**Design Review Board Case #2018-0005**  
**Carlyle Plaza Two – South Residential Building**

Application	General Data	
<p><b>Project Name:</b> Carlyle Plaza Two – South Residential Building</p> <p><b>Location:</b> 800 Bartholomew Street</p> <p><b>Applicant:</b> Alder Branch Realty Limited Partnership, LLLP; represented by JM Zell Partners</p> <p><b>Architect:</b> Arquitectonica</p>	<b>DRB Date:</b>	July 19, 2018
	<b>Site Area:</b>	1.28 acres
	<b>Zone:</b>	CDD#11
	<b>Proposed Use:</b>	Residential
	<b>Dwelling Units:</b>	368 units
	<b>Gross Floor Area:</b>	363,222 sf
<b>Purpose of Application:</b>		
DRB review of brick wall detail and setback for the low-rise liner units on the west elevation proposed with the first phase of the Carlyle Plaza Two development.		
<p><b>Staff Reviewers:</b> Robert Kerns, AICP, <a href="mailto:robert.kerns@alexandriava.gov">robert.kerns@alexandriava.gov</a>          Thomas H. Canfield, AIA, <a href="mailto:tom.canfield@alexandriava.gov">tom.canfield@alexandriava.gov</a>          Nathan Imm <a href="mailto:nathan.imm@alexandriava.gov">nathan.imm@alexandriava.gov</a>          Bill Cook, AICP <a href="mailto:william.cook@alexandriava.gov">william.cook@alex

**Figure 1 - Building Elevations Comparison**

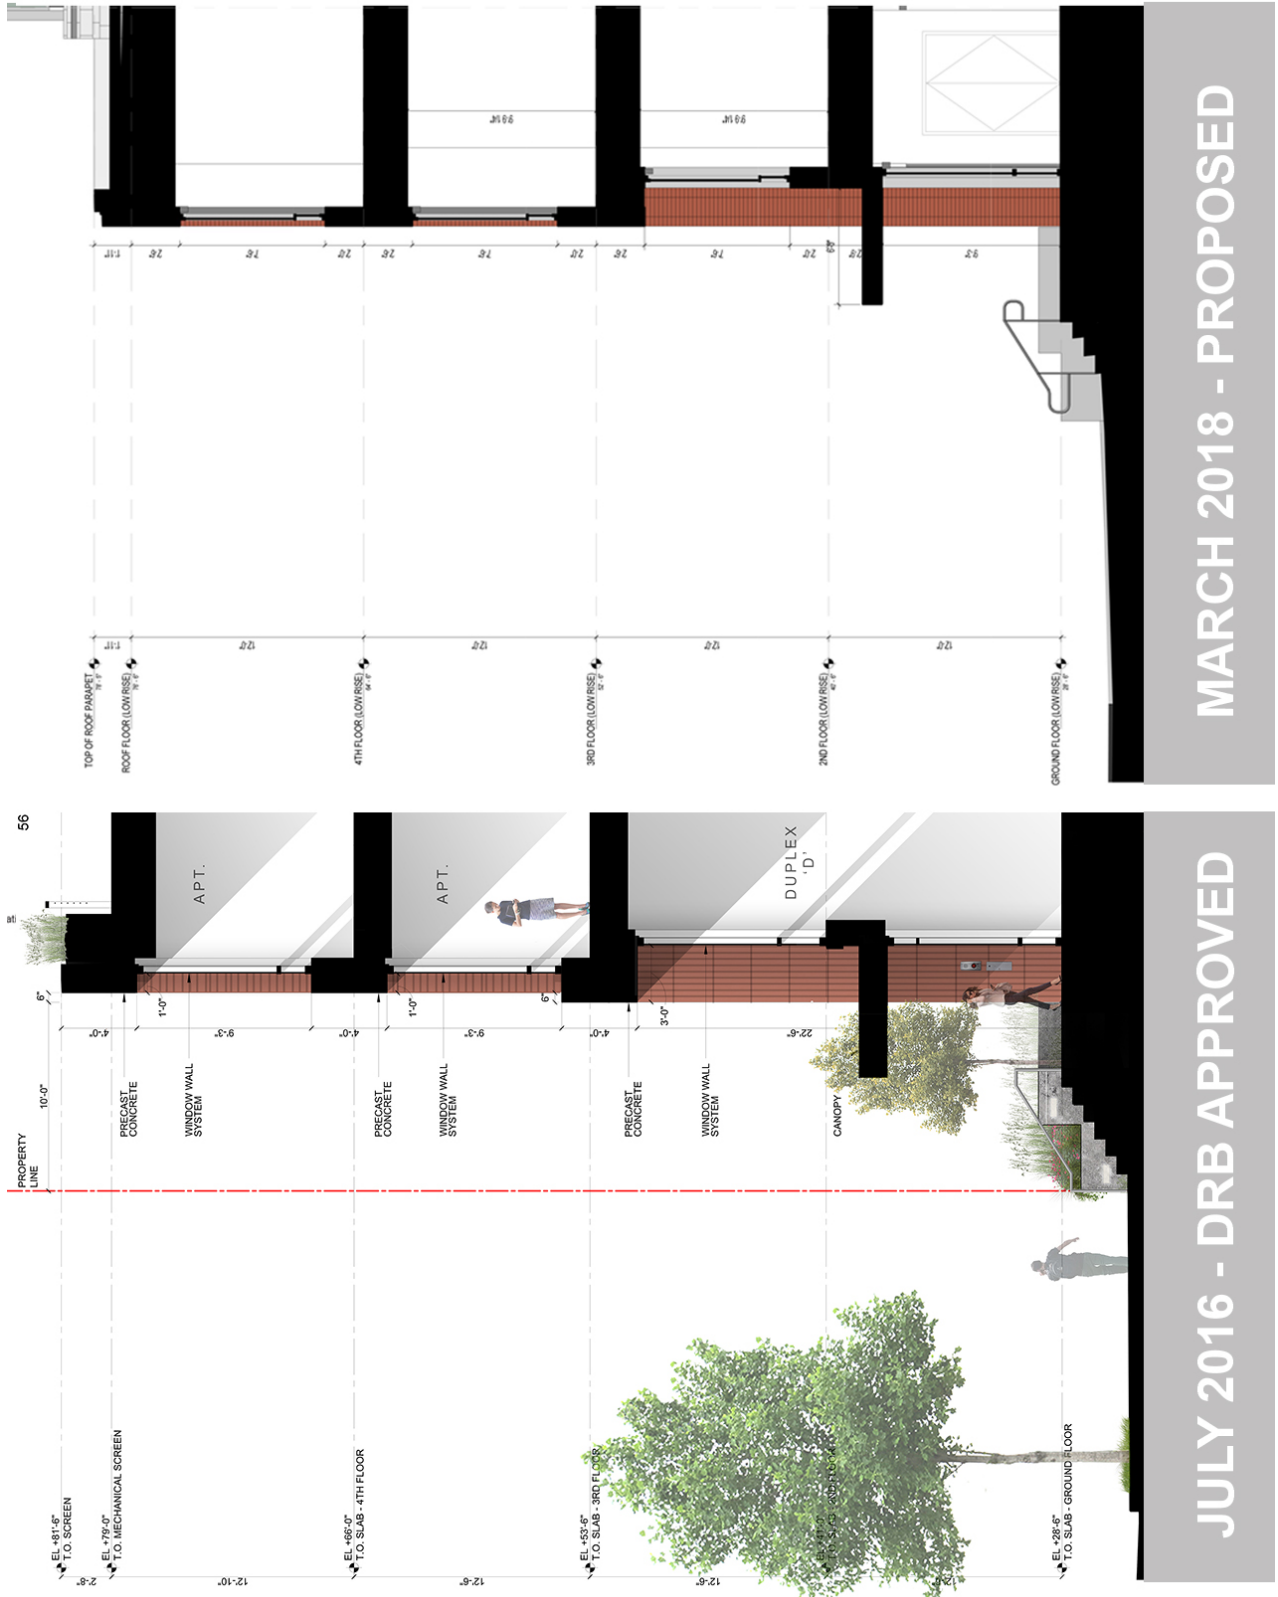
The primary, west-facing, façade of the low-rise liner units is comprised of two planes defined by an offset between the face of the building materials. The front plane forms a series of steps that cascade across this façade providing both horizontal and vertical movement that relates to the cascading effect of the glazing pattern proposed on the South Residential Tower (Figure 1).

The originally approved (July 2016) west façade employed a design strategy that highlighted the contrast between the front, stepped masonry plane and the secondary surface beyond, with additional contrast provided by a shift from a vertical brick pattern in front to a horizontal pattern in the rear. The conditionally approved March 2018 façade has a horizontal brick pattern on both planes, but with different brick sizes on each plane.

While Staff finds the original concept providing a stronger and more elegant contrast between the planes, the proposed revision with an 8 ½ inch depth satisfies the condition of the March 2018 DRB approval and returns some of the strength and clarity of the original design. Staff recommends DRB **approval** of the proposed wall design.
